Hume Coal and Berrima Rail Project

Independent Planning Commission Determination Phase Submission

Prepared for Hume Coal Pty Ltd
July 2021

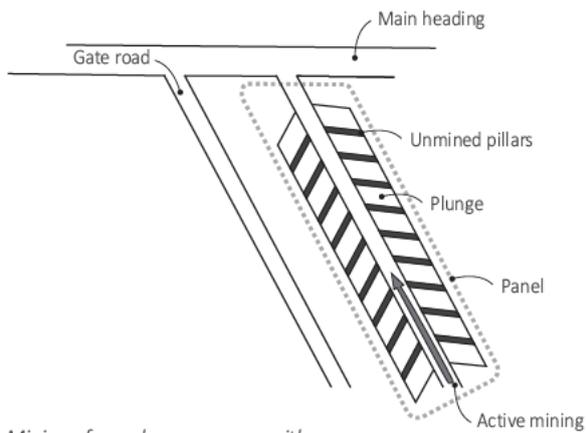
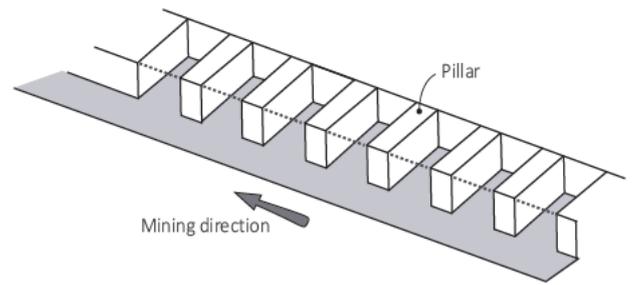
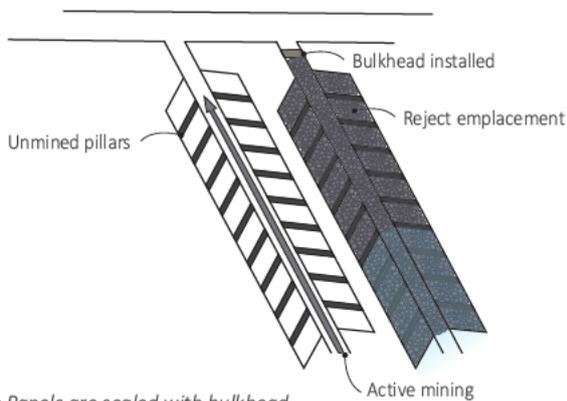
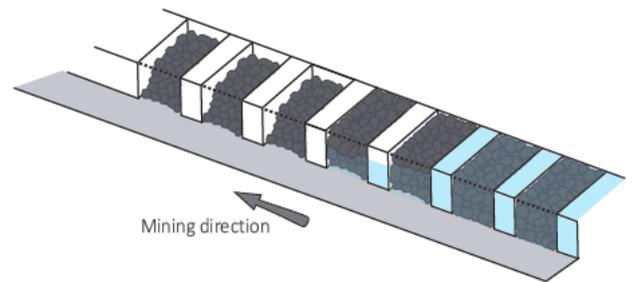
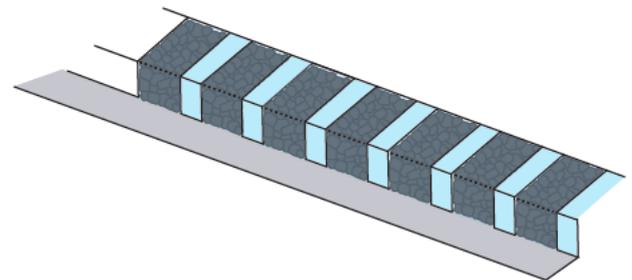
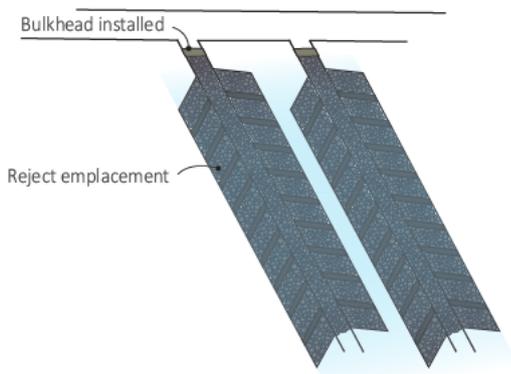
Page number	Discussions / comments	Hume Coal response	Reference to where additional information can be found
		Project has demonstrated that the water quality risk is low. As such, any water quality risk associated with potential bulkhead failure (albeit unlikely) is low.

Hydraulic head in bores schematic pre-mining and mining
 Hume Coal Project
 Updated water assessment
 Figure 5.1

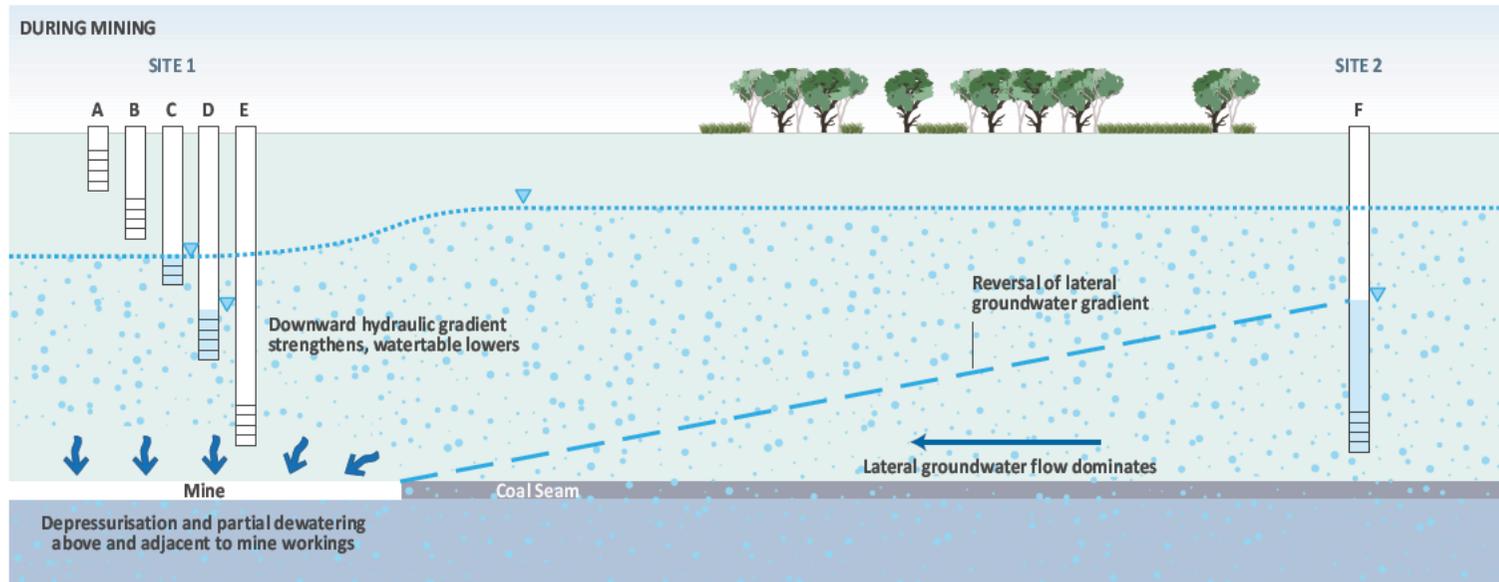
Further, the schematic in Figure 5.1 illustrates the manner in which depressurisation of a groundwater source can occur without dewatering. Although bores above the mine will be depressurised (ie experience drawdown), the formation will remain saturated throughout mining and bores will continue to operate, albeit at a lower pressure head and likely at a lower yield. As observed at Tahmoor and the Berrima Colliery, saturation within the Hawkesbury Sandstone above the mine remains despite mining of a coal seam(s).

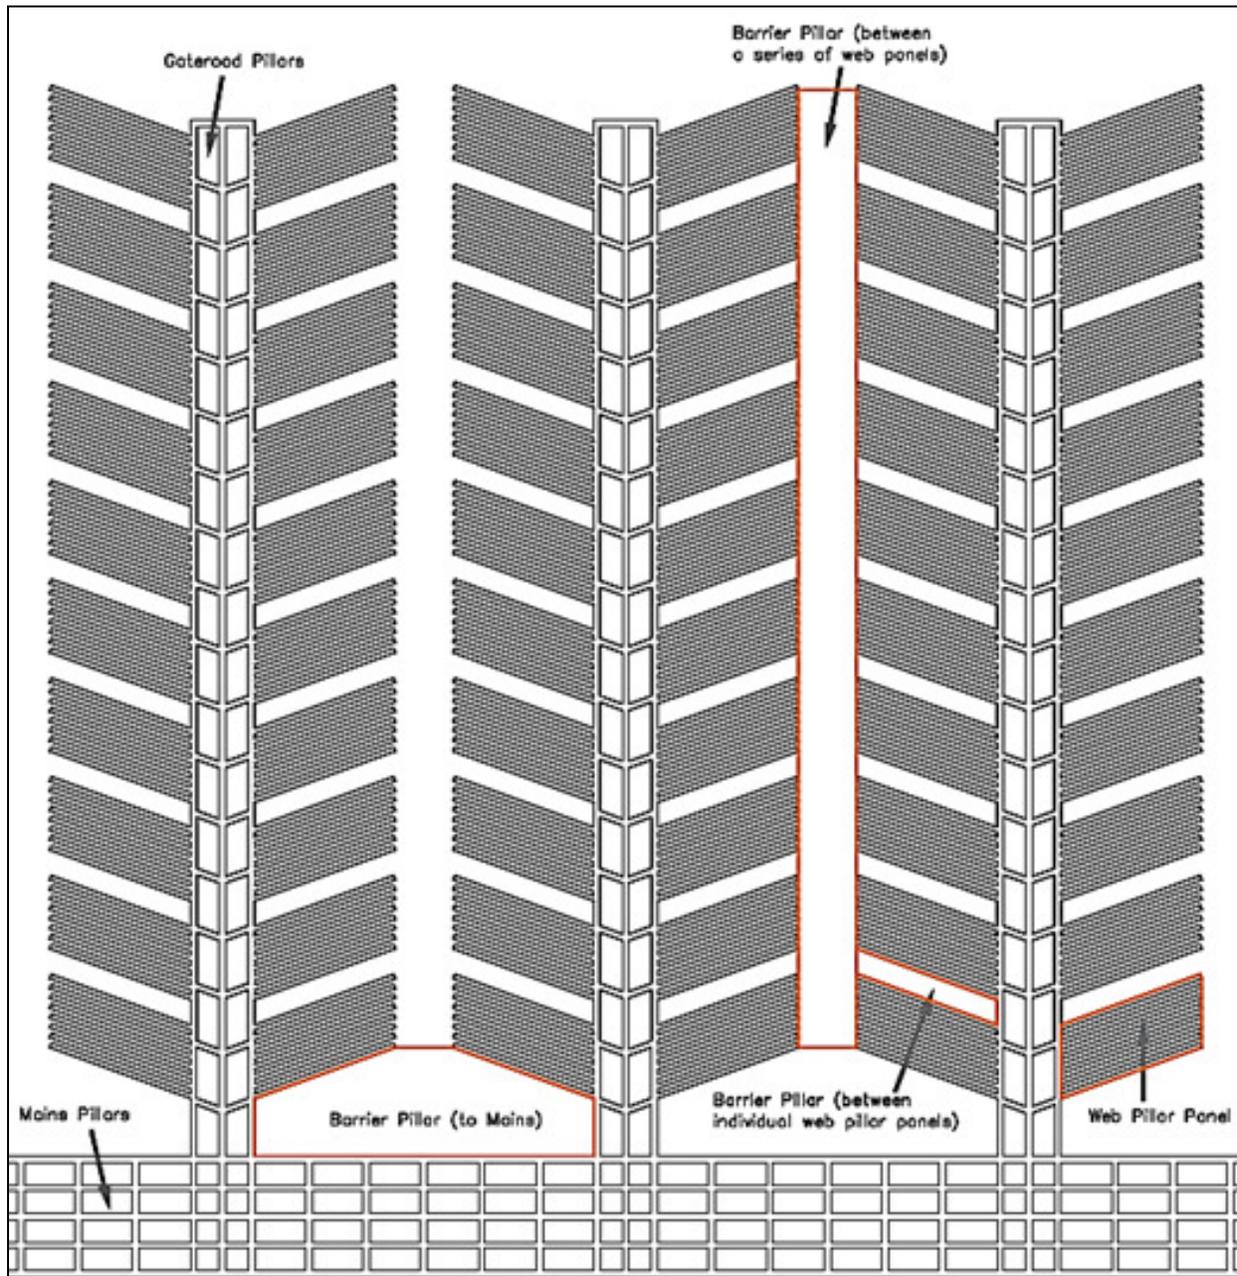
The proposed pine feather mining technique is a novel method, involving some innovative aspects of mine design and layout. It has been designed with the objective of minimising surface

subsidence and impact on overlying groundwater aquifers within the overburden. The method has been designed to also provide underground wastewater storage capacity in mined-out areas.
